Addendum to the Closure Units 1 and 2 Work Completion Report, Revision 1
Three Kids Mine
Henderson, Nevada

Project No. 23-01-200

APPENDIX A
Responses to NDEP Comments made on September 16, 2026
to the Addendum to the Closure Units 1 and 2 Work Completion Report, dated July 15, 2026

MODEL 1-2
AERIAL DATE: MAY 19, 2025
WMK VERIFICATION: MAY 21, 2025

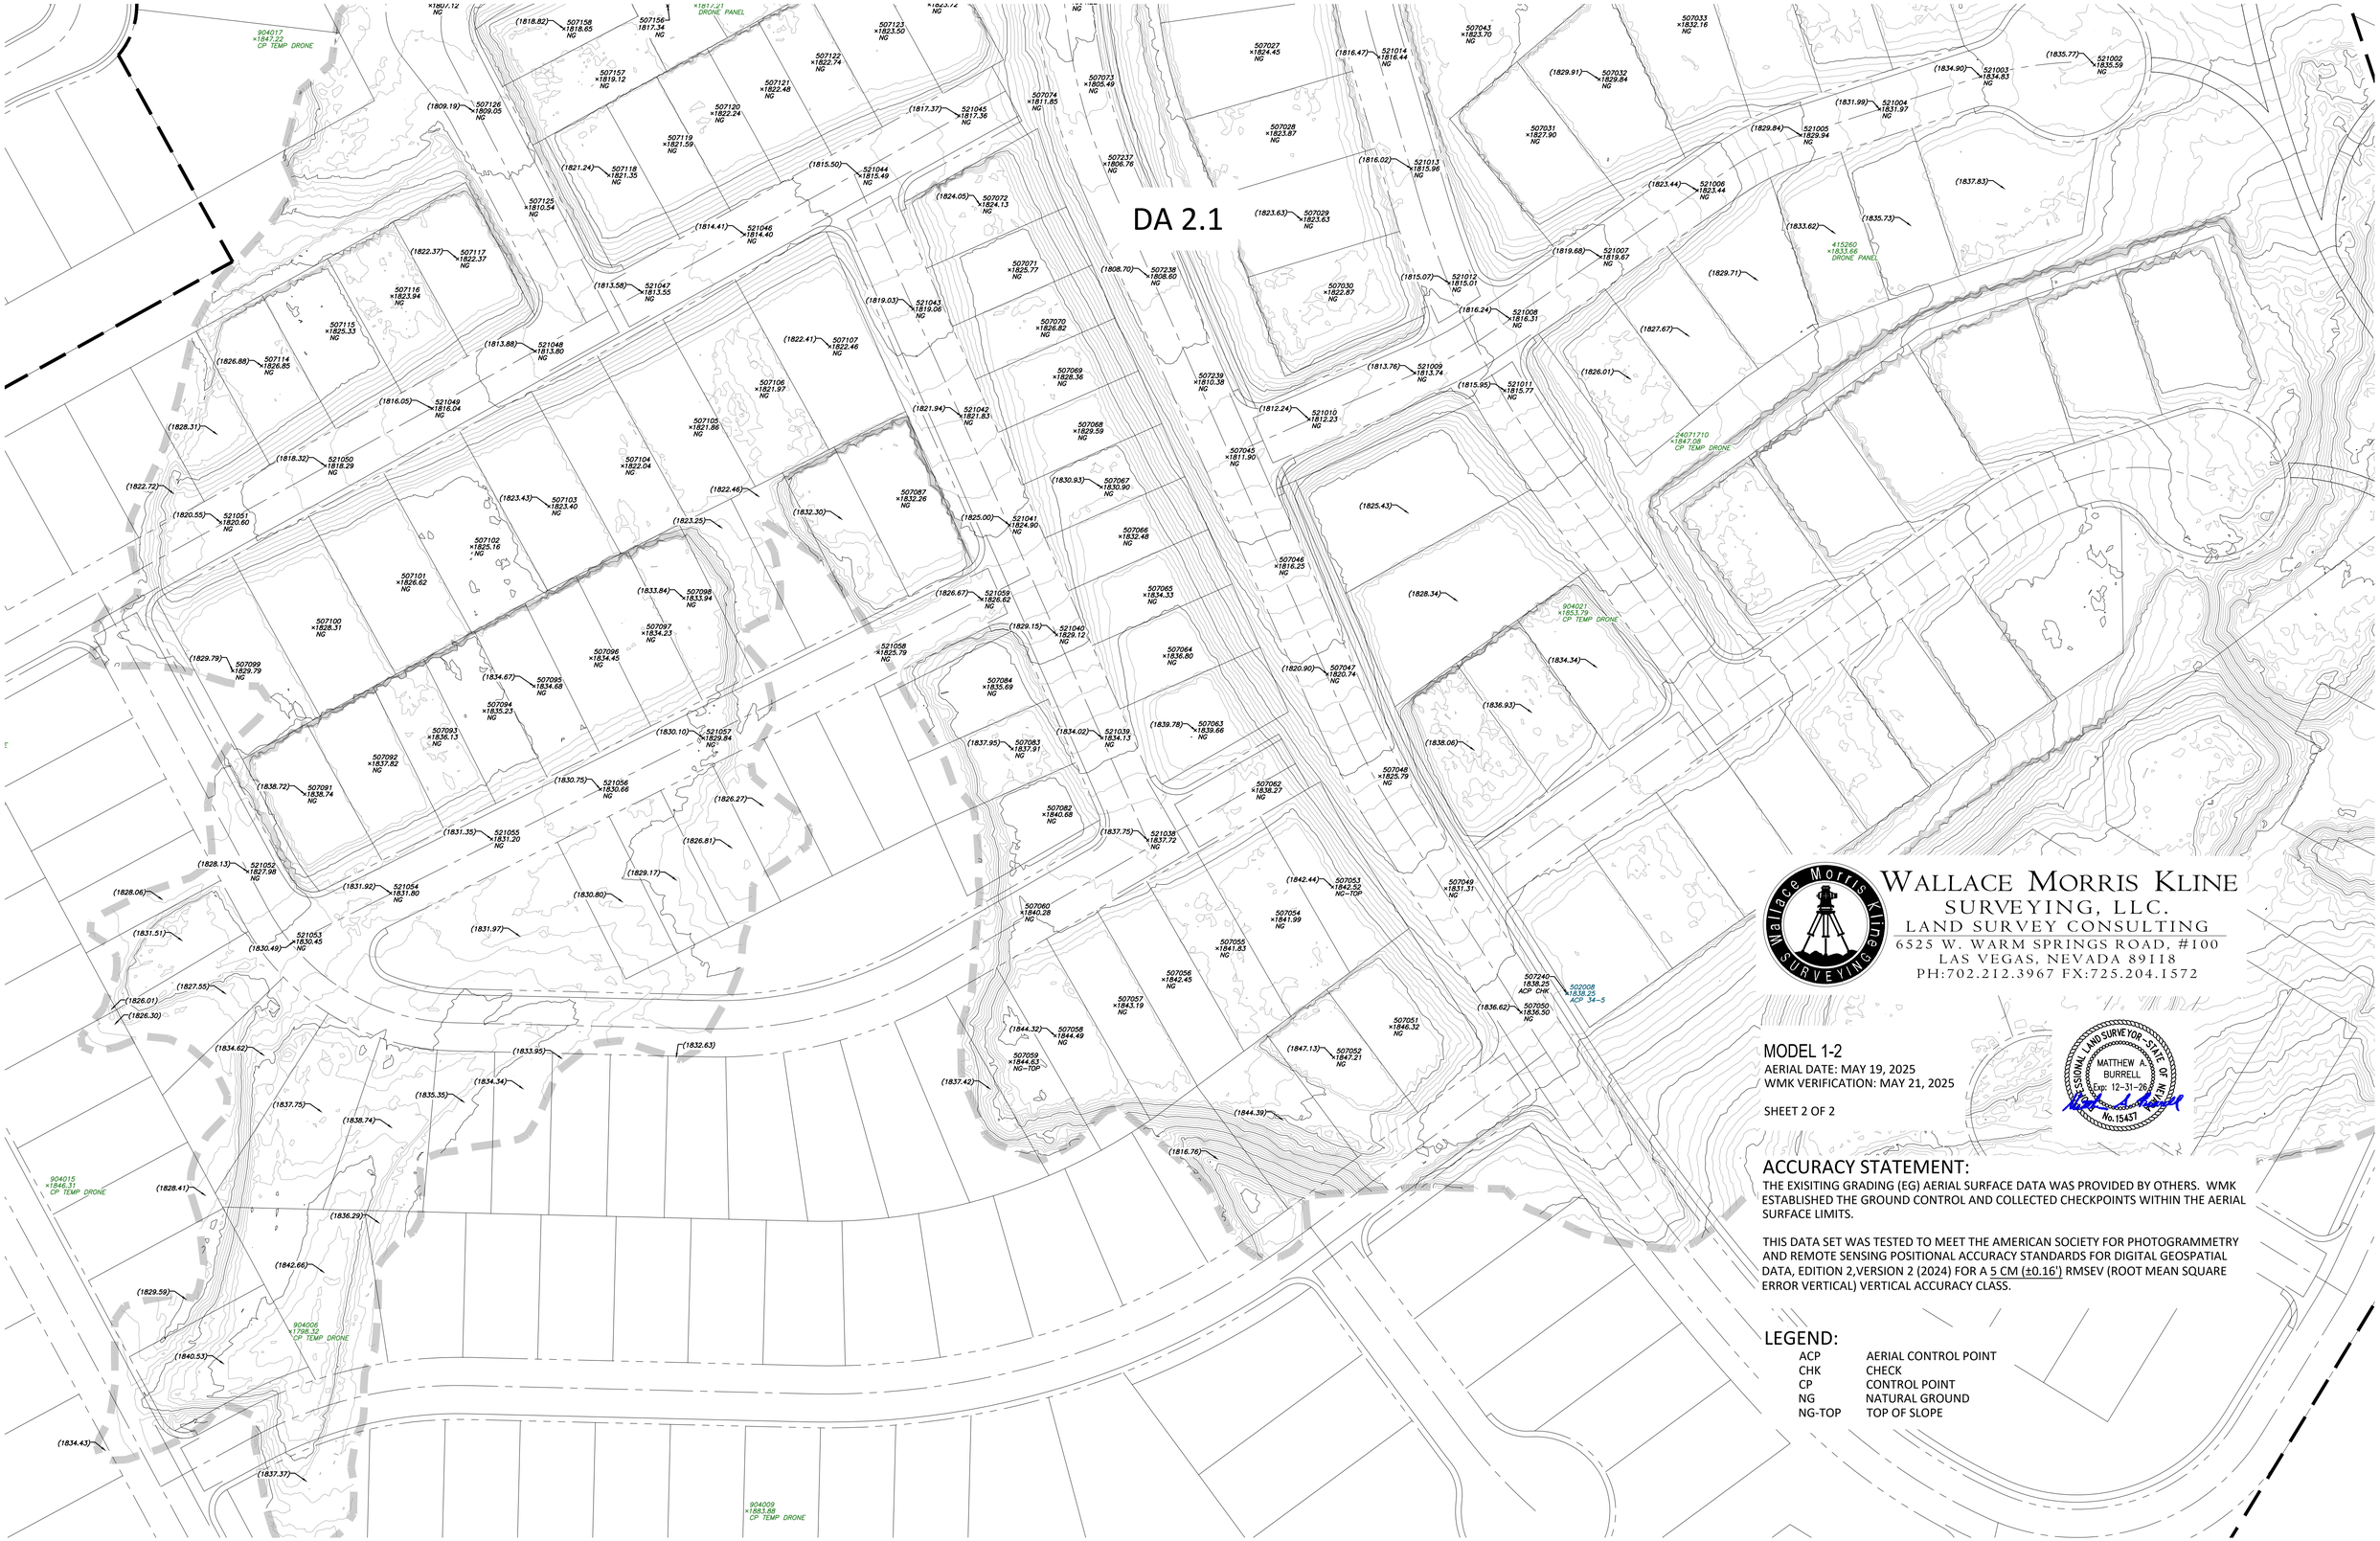
1. **General Comment #1** – Verified survey data for the pre-cover surface is included in Appendix E of the *Closure Units 1 and 2 Work Completion Report, Revision 1* (WCR). The models included in Appendix E of the WCR provide pre-cover elevations for many, but not all, house lot pads located wholly or partly within Closure Unit 1. NDEP assumed that the pre-cover elevations that were not included in the WCR would be presented in the *Addendum to the Closure Units 1 and 2 Work Completion Report* (Addendum). However, those elevations are not included in the Addendum either. Identified examples include house lot pads 83, 84, 86, 87, 89-91, 93-96, 98, 107-113, 125-127, 168-170, 172, 173, 185-192, 208, 210, 203-206, 220-227, 234, 244, 245, 256, 318-323.

Although the WCR and Addendum collectively use multiple lines of evidence to demonstrate that placement of the required 10-foot native soil cover has been met (i.e., pre-cover verification models in Appendix F of the WCR and post-cover verification survey data in Appendix G of the WCR and Appendix C of the Addendum), NDEP considers it important that the house lot pad pre-cover elevations that were not included in the WCR be presented in the Addendum. Accordingly, please revise the appropriate pre-cover verification models from Appendix E of the WCR and submit the revised models with the revised Addendum.

Note that pre-cover elevations along certain roads are also not included in some models; it would be helpful to also include this data in the revised models, where possible.

Information regarding the pre-cover verification process is included in the *Closure Units 1 and 2 Work Completion Report, Revision 1* submitted to NDEP on July 23, 2026. In response to NDEP comments, pre-cover surface elevations pulled from the aerial topography for additional house pads were added to Models 1-2, 1-4, 1-9, and 1-12. Revised WMK-verified survey pre-cover surfaces are included as Appendix C.

Verified survey elevation data for the pre-cover surfaces included in Appendix E of the WCR contained sufficient data for the licensed surveyor to verify the aerial topography used in the pre-cover verification models. As a result, elevations were not necessarily identified on each house pad. The verified survey data for the pre-cover surface, the pre-cover verification models, and the post-cover verification survey data demonstrate the placement of 10 feet of cover. In response to NDEP's request and as an additional line of evidence, revised pre-cover surface figures are provided with this addendum for Models 1-2, 1-4, 1-9, and 1-12 depicting pre-cover elevations pulled from the aerial topography for additional house pads. Revised pre-cover figures are included as Appendix C.
